Metropolitan Sanitary District
of
Greater Chicago
Tunnel and Reservoir Plan
Special Evaluation Project
Interim Report

U.S. Environmental Protection Agency
Region V
Water Division

March 1988

FIGURE 11: COMPARISON OF TUNNEL AND QC-2 WATER LEVELS

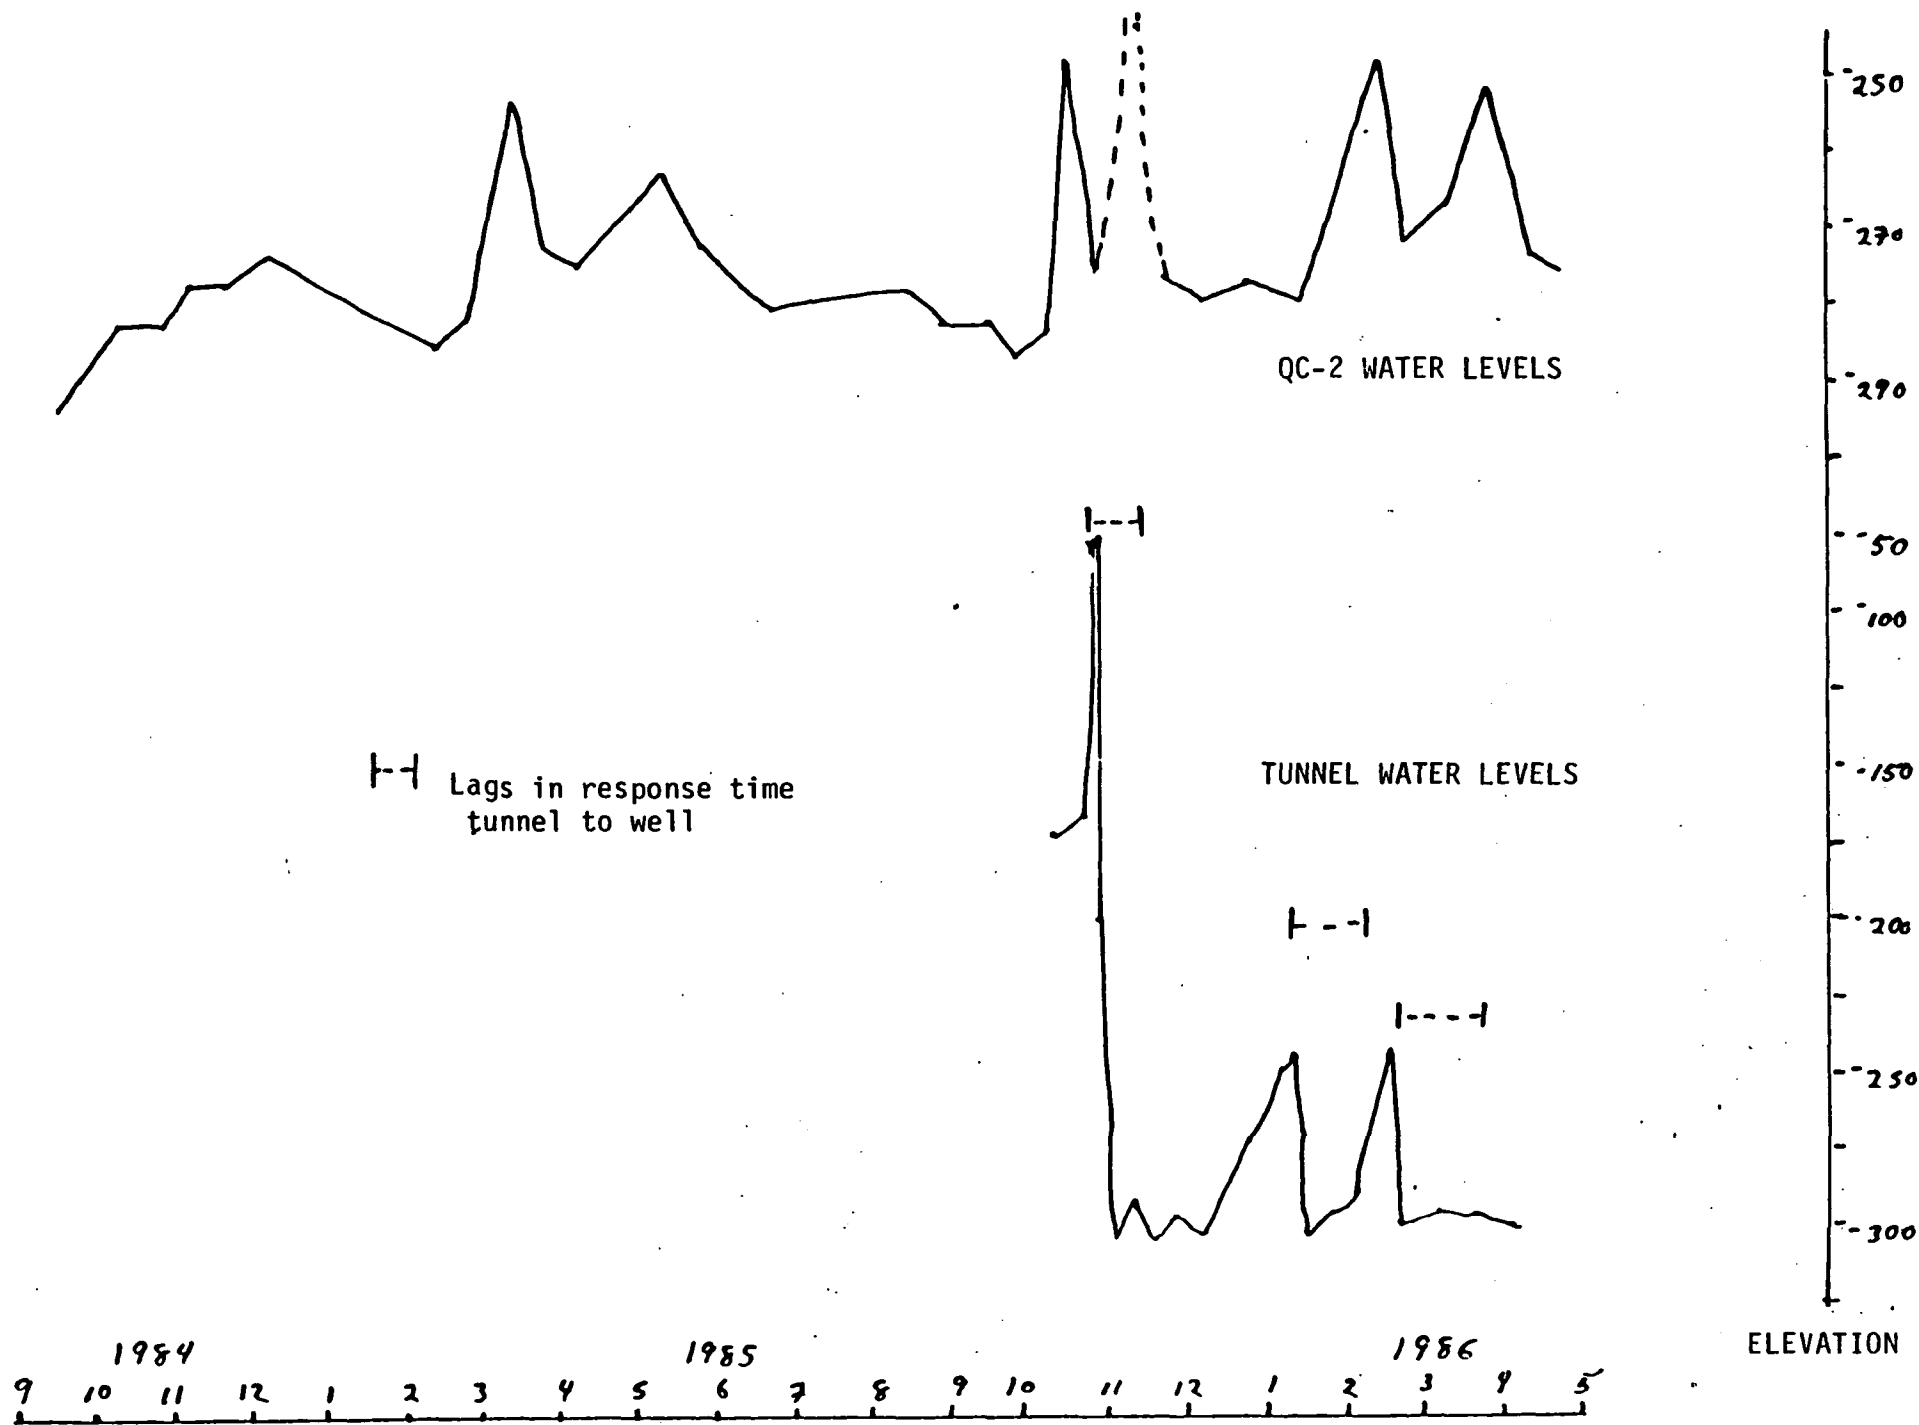
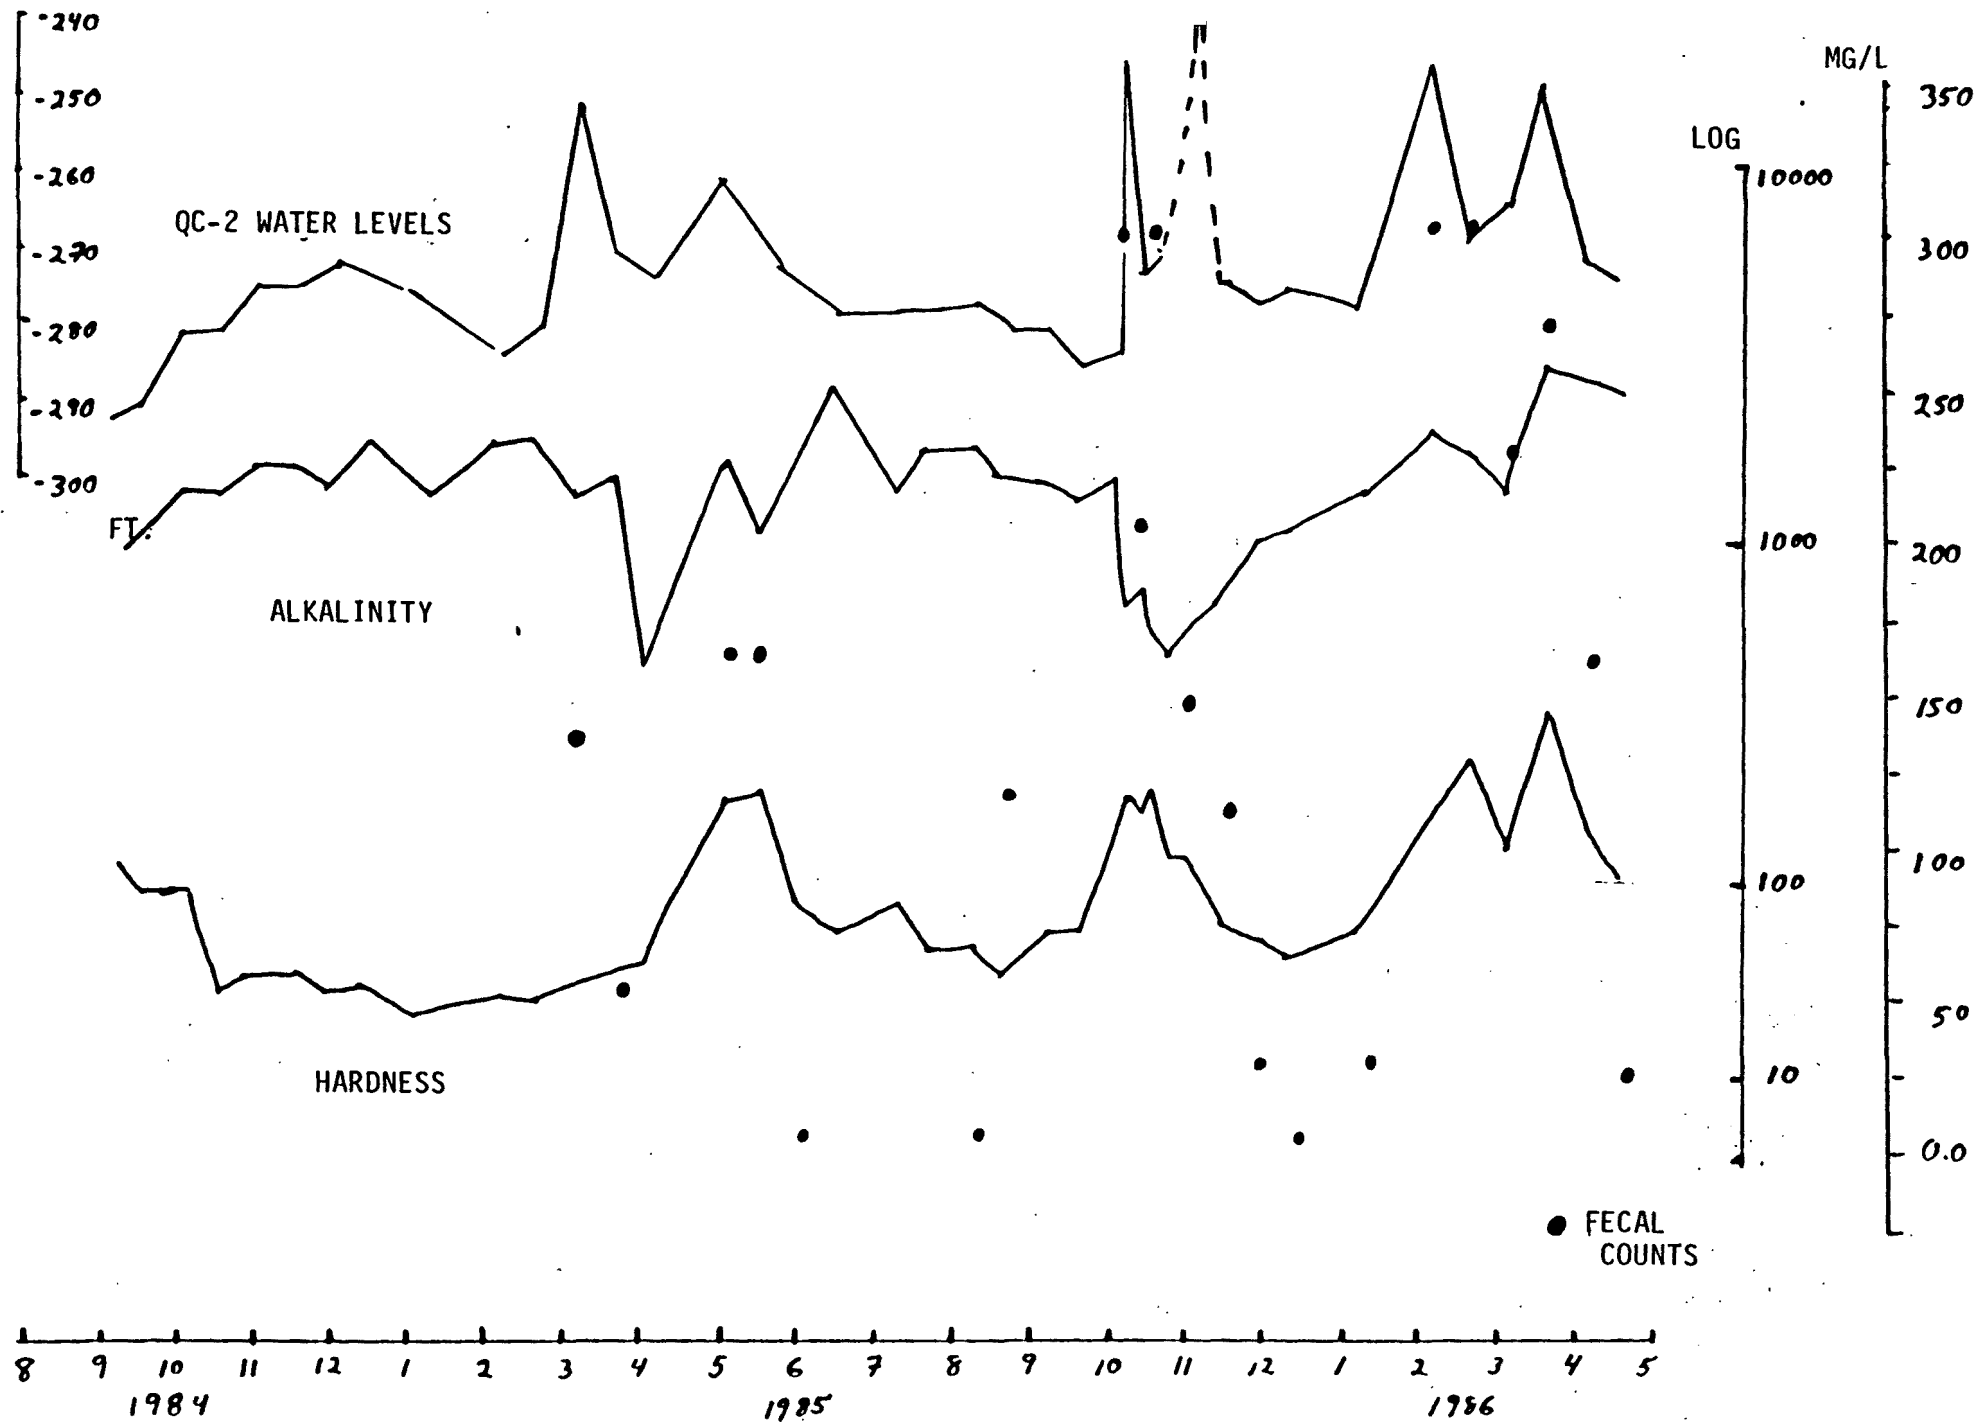
The MSDGC should perform a correlation analysis using the continuous level recorder data for the QC-2 well to better define the lag time between high water in the tunnel and the rise in the water well level. Clearly the aquifer around the QC-2 well is experiencing some periodic contamination. This phenomenon should be studied for a longer period of time to determine if the change in water quality has any long term impacts.

The presence of contaminated groundwater in Calumet well QC-2, which is 60 feet from the tunnel, occurs within one month of high water levels in the Calumet tunnel. The flow velocity of the observed contaminated groundwater is much greater than the predicted contaminant flow of 70 feet in 288 days, as predicted by the Harza Engineering model in 1972. The QC-2 well is finished in a less fractured zone and still has a relatively quick response, as compared to predicted flow velocities. In order to properly assess the extent of the contaminant flow, a model based upon flow in fractured bedrock (the Harza model used a worst-case homogeneous permeability factor) would be required. In addition to the modelling effort, a series of wells in a line perpendicular to the axis of tunnel could be established at the QC-2 site to assess the extent of the contaminant plume during exfiltration events.
